ADDENDUM

Project: Hobble Creek 1, 2, 3 Chapel HVAC

Addendum No.: Two

Date: February 5, 2018

EG601

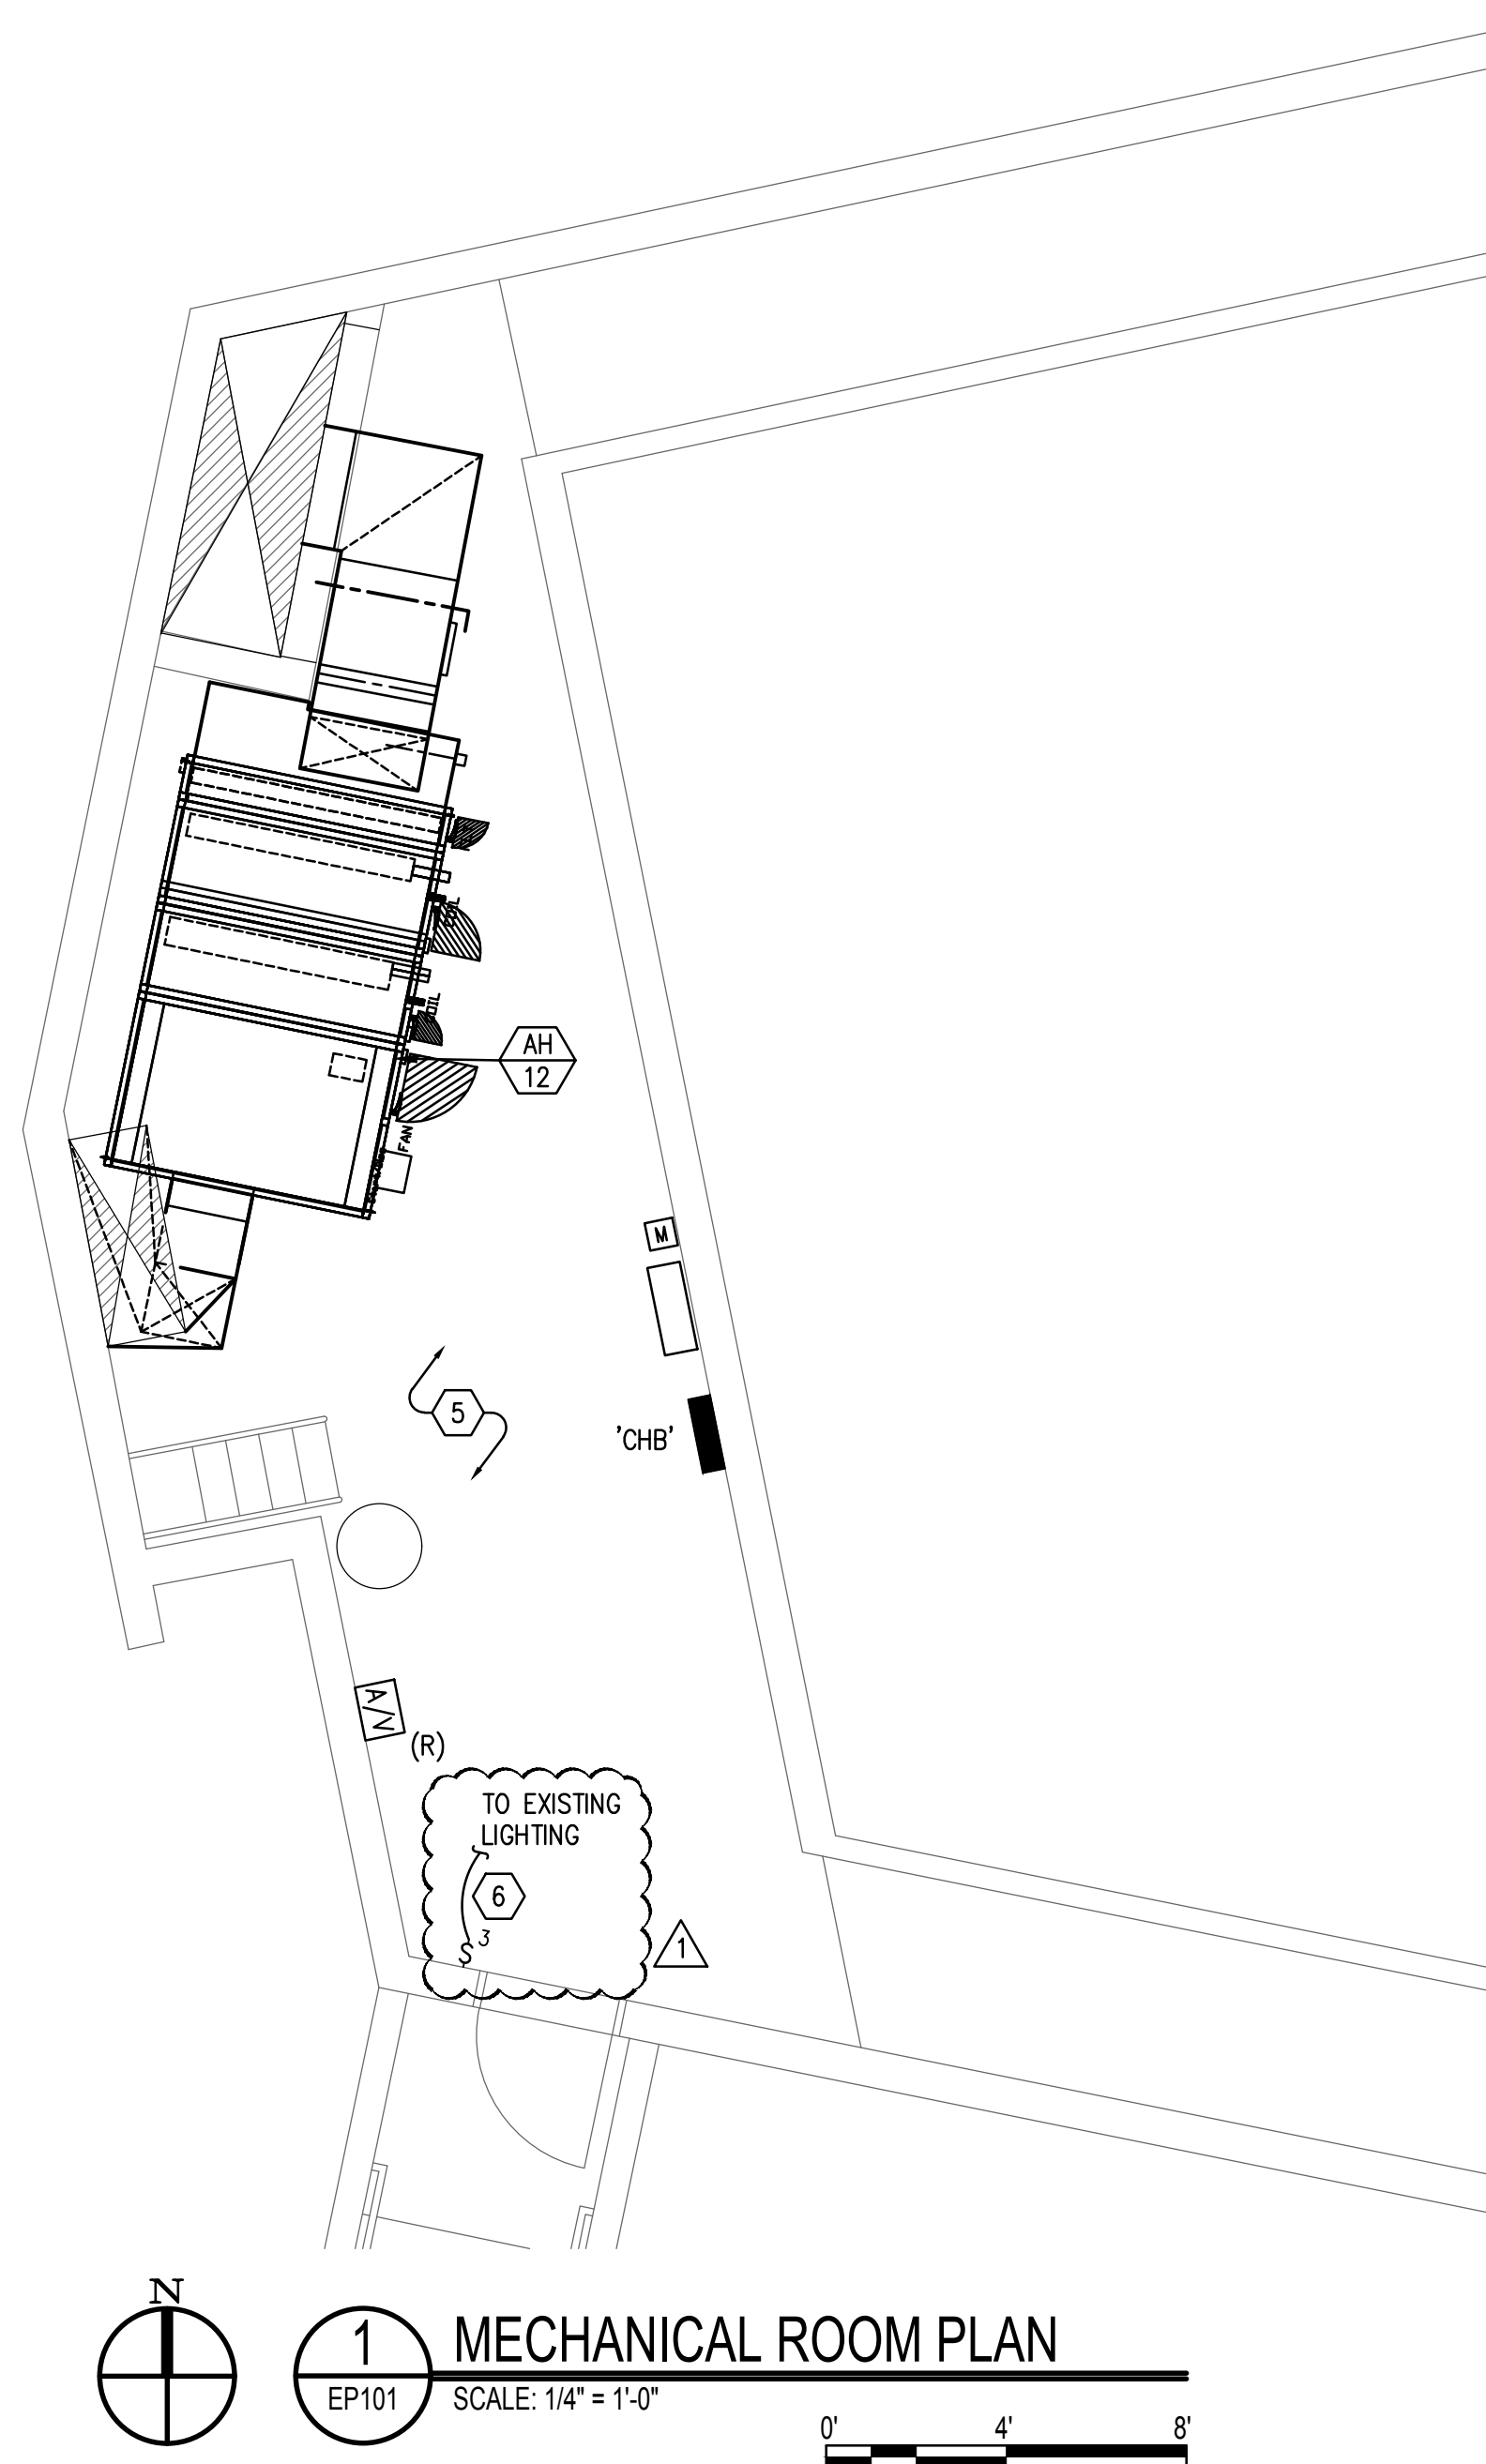
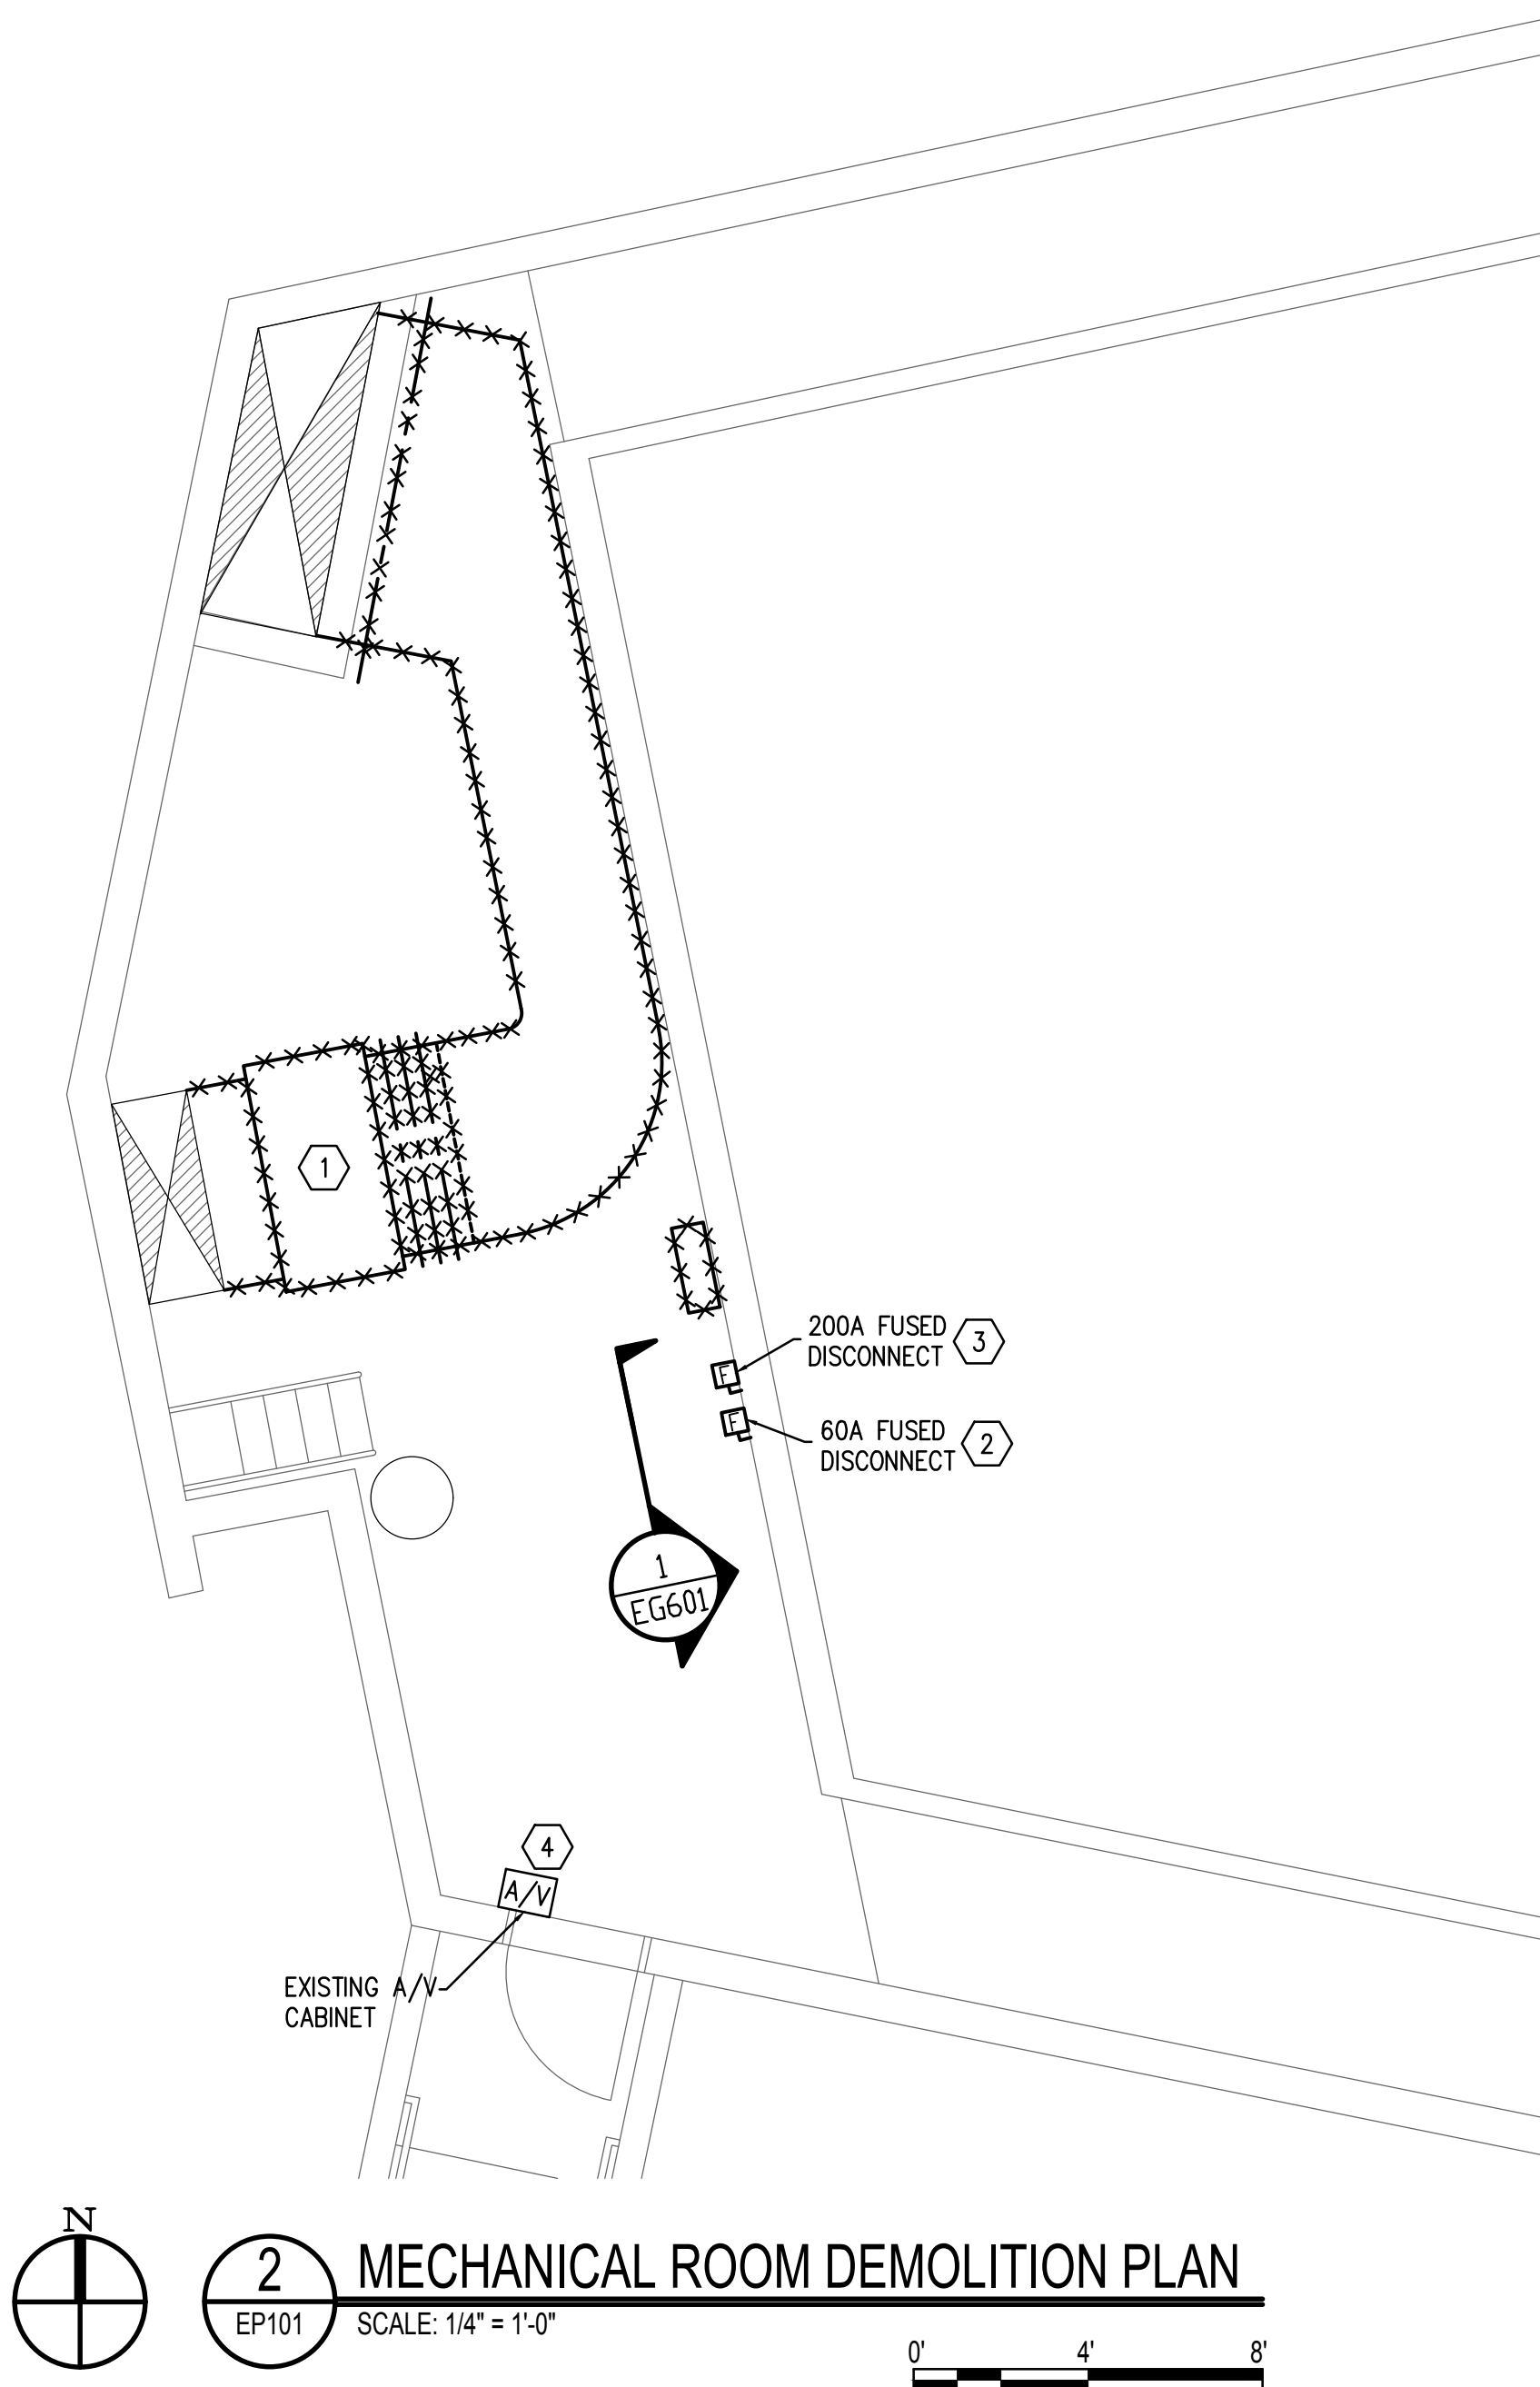
- 1) Updated Panel Schedule CHB. Changed from Main Lugs to Main Breaker and added spares and circuit for thermostats.

- d. *Question 4: Can we use the existing wire from the 200 amp disconnect to power panel CHB?*

Response: The contractor will need to run new wire as indicated on revised drawings.

EP101

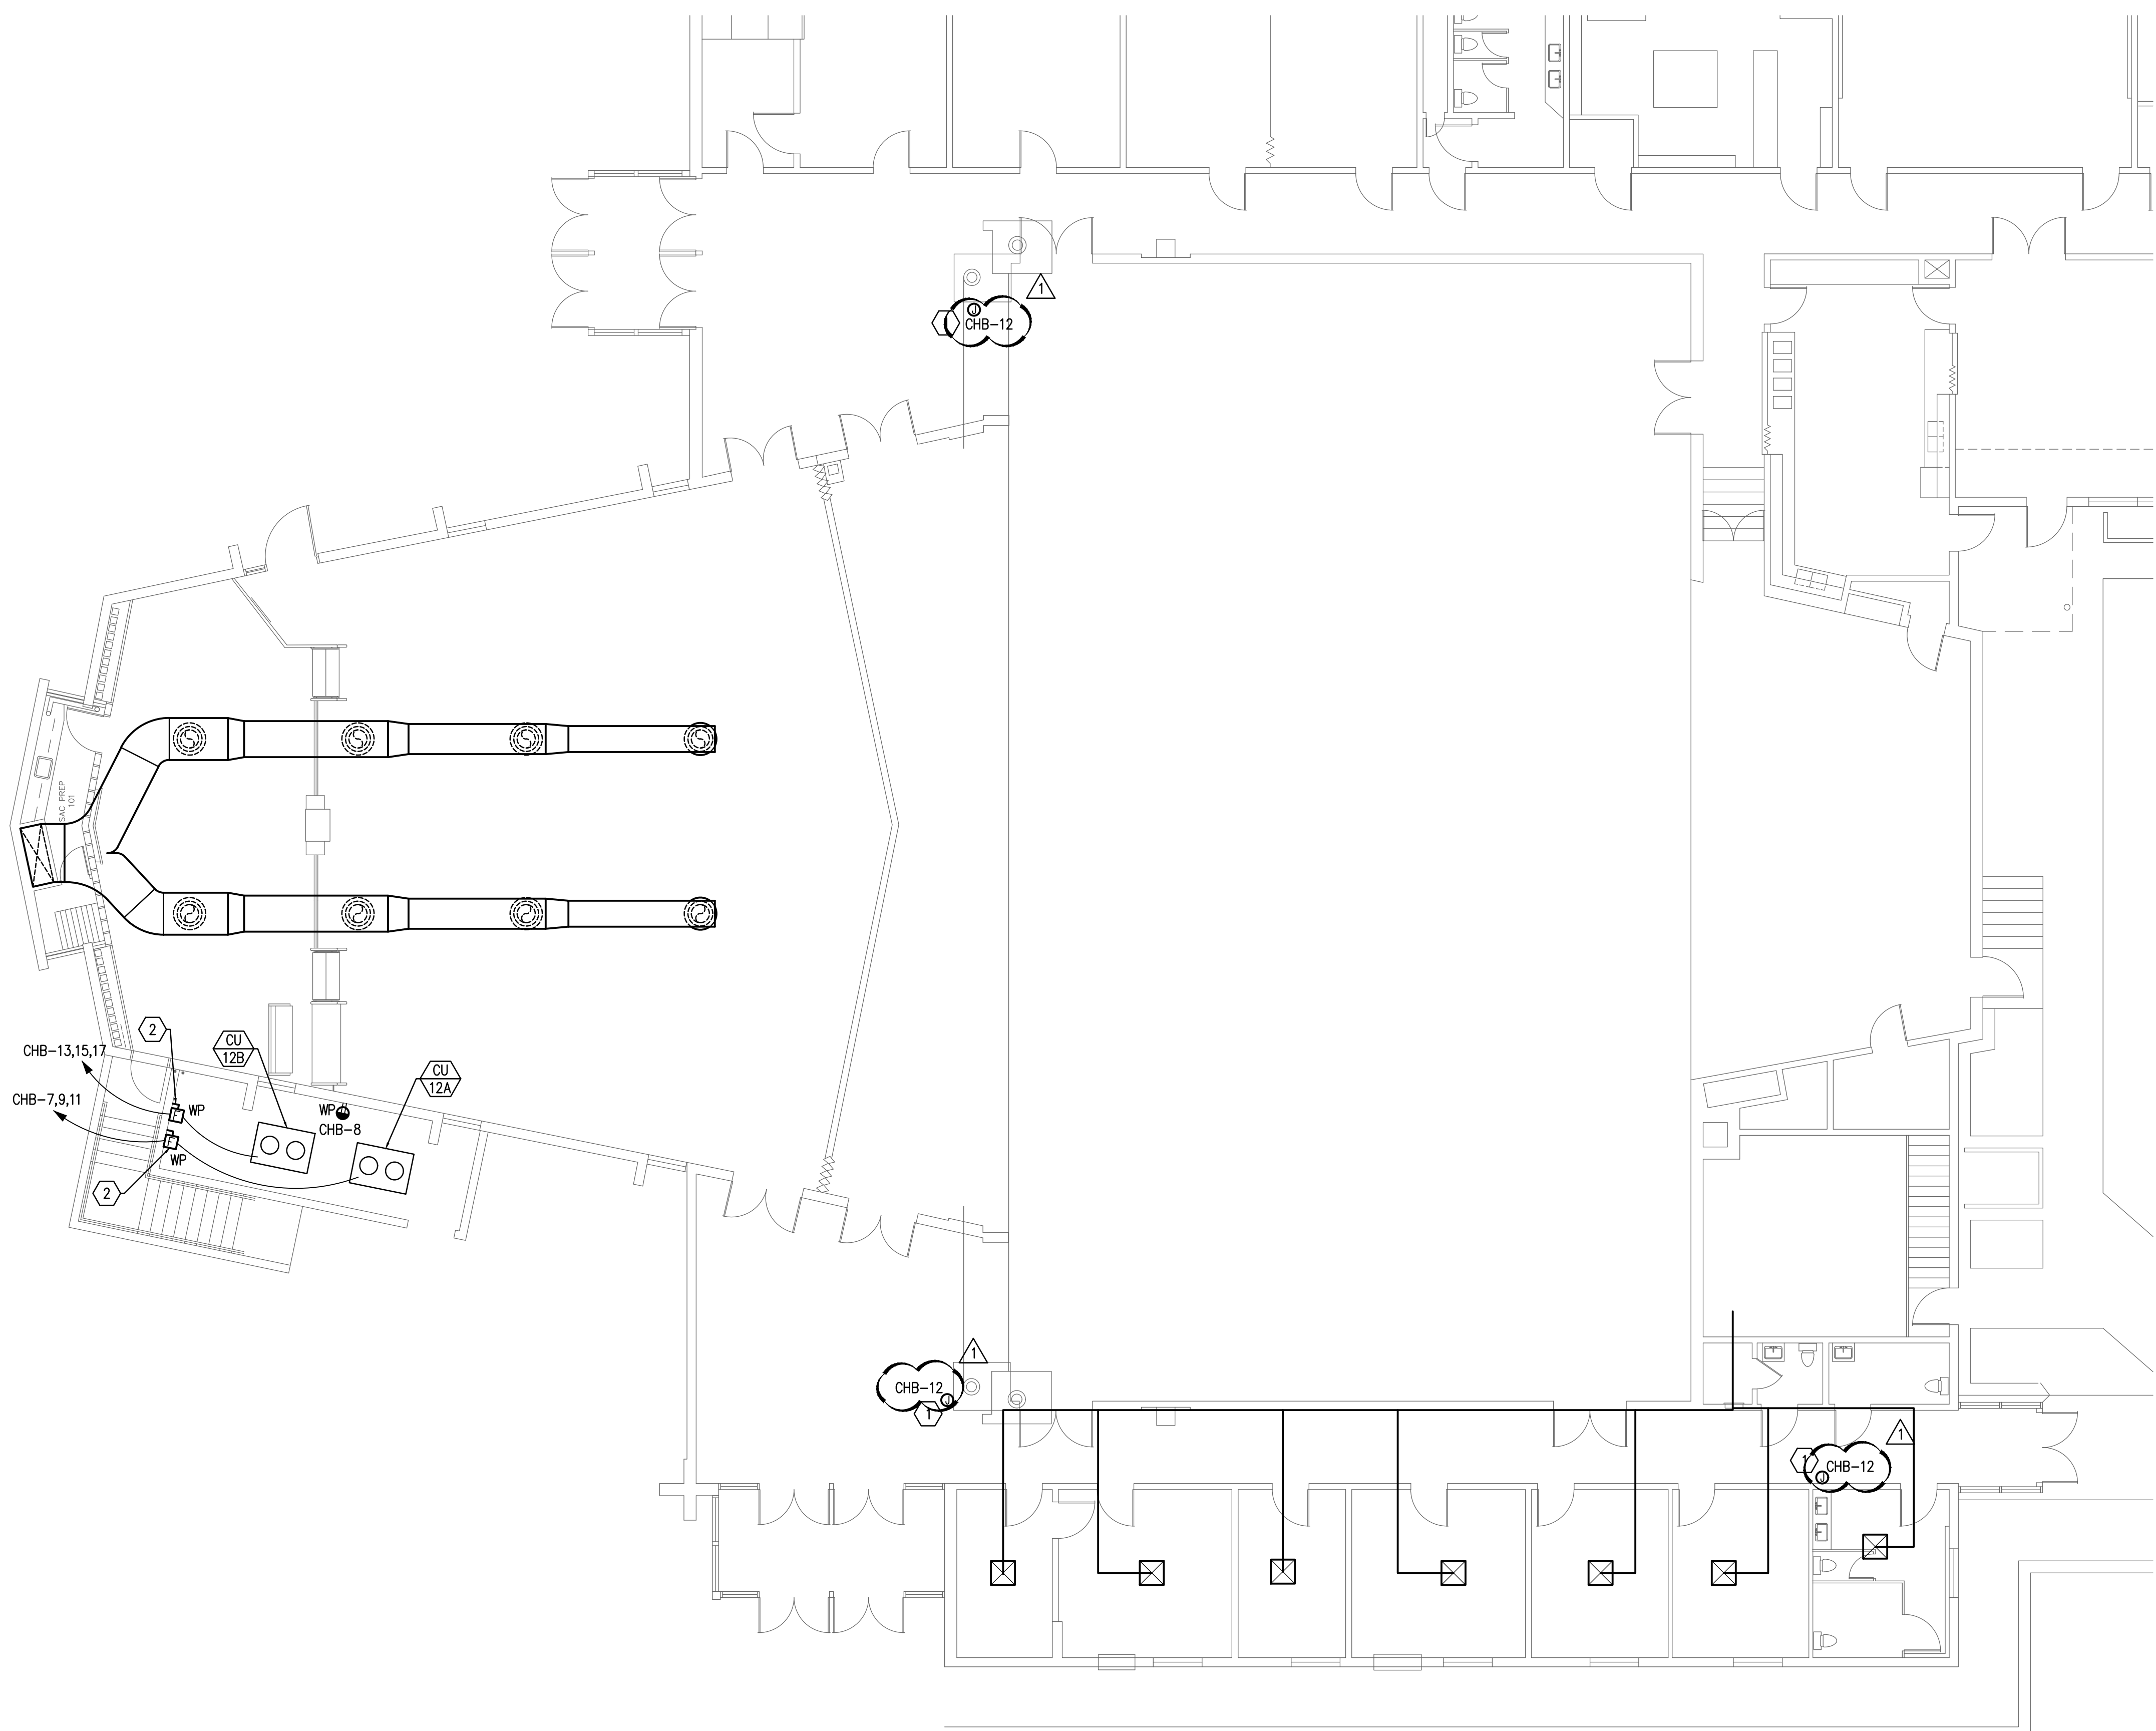
- e. Refer to attached Sheet **EP101**.
 - 1) Added light switch by new exterior door. Modified Keyed Note 3. Added Keyed Note 6. Modified General Note H.
- f. Refer to attached Sheet **EP102**.
 - 1) Added circuits for thermostat j-boxes. Modified General Note H.

- b. *Question 2: With the change in the door location to enter the mechanical room do we need to add an additional switch so that the lighting can be turned on as you walk in that door?*

- e. *Question 5: Can we refeed the existing 60 amp 3 phase disconnect by installing new junction box in place of disconnect or will we need to run new wiring all the way back to source?*

Response: 3-way light switch added by new exterior door on revised drawings.

Response: The preference is to keep the wall uncluttered. Locate the panel closer to the existing 60A disconnect if needed to eliminate the need for j-boxes to extend existing conductors.
